Case No. 11-141PFR Kathryn Commons Addition

Proposed Plat

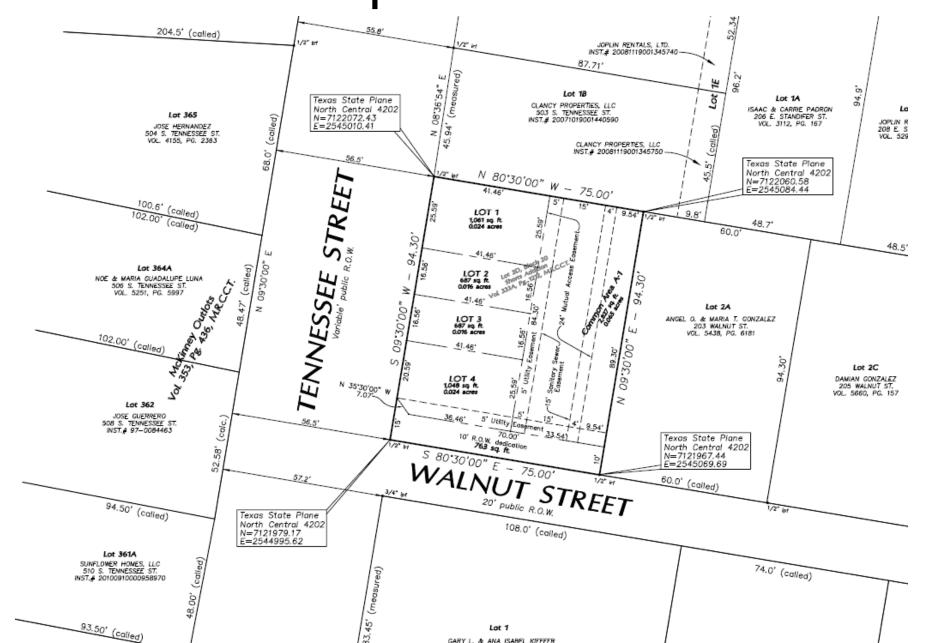
- The applicant revise the plat to provide a notation indicating that the proposed common area will be owned and maintained by a homeowners' association.
- The applicant revise the plat by labeling Common Area A-1 as a drainage easement.
